Narrative for Set Back Survey Review

Re: Setback Survey

Columns 1 and 2 -Lanai:

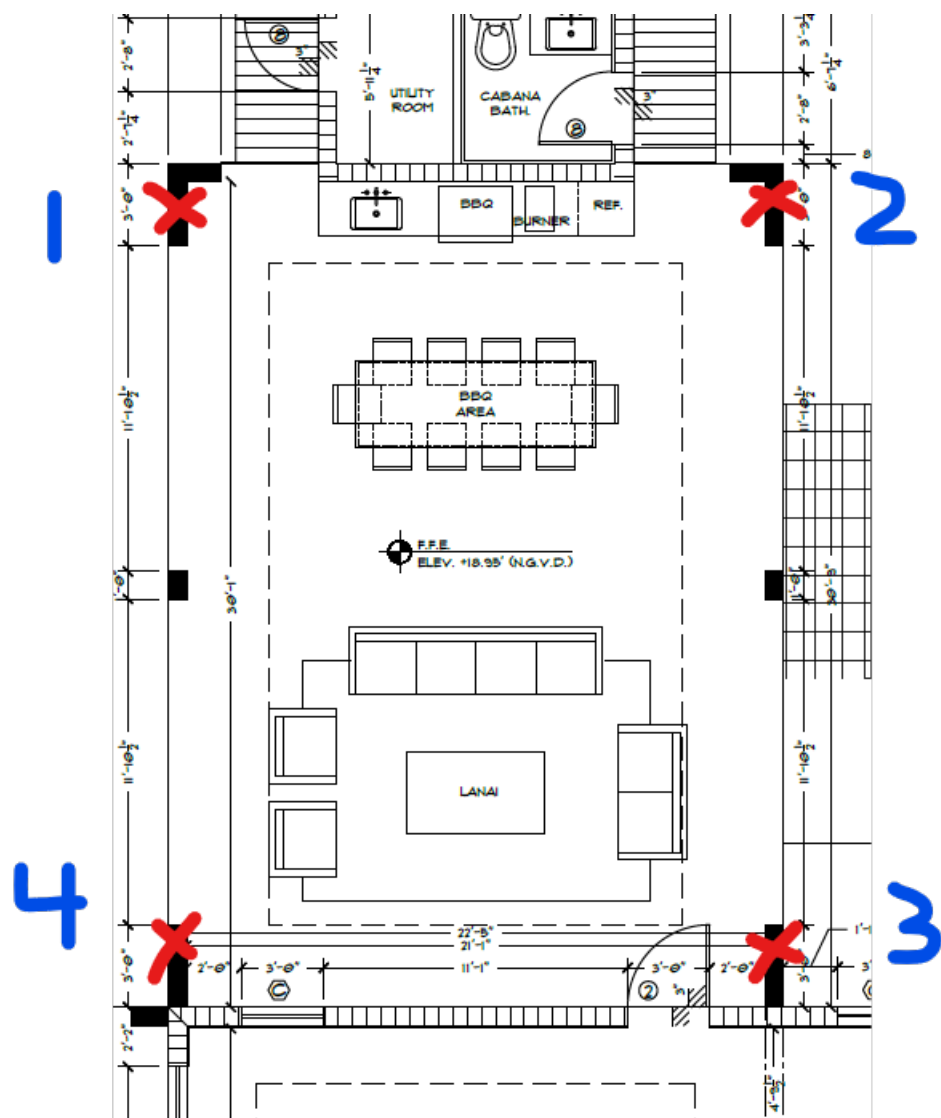
Columns 1 and 2- Lanai: These columns are rectangular and are constructed as per the permitted structural plans

The columns are rectangular shape

Columns 3 and 4 at Lanai:

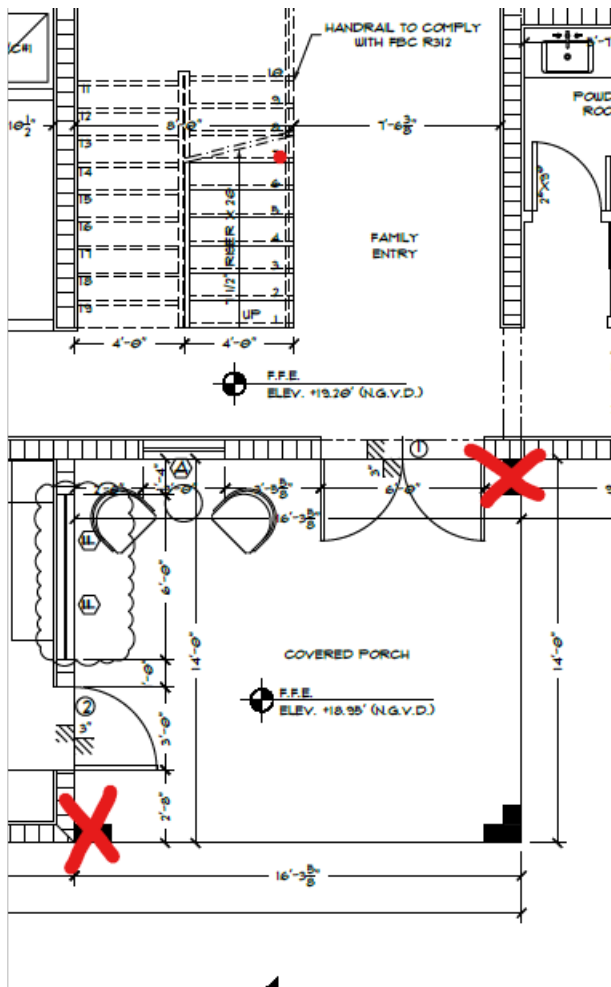
Columns 3 and 4 are not there and were never part of the permitted structural plans.

The rectangular columns are not part of structural plans and are not part of the building.
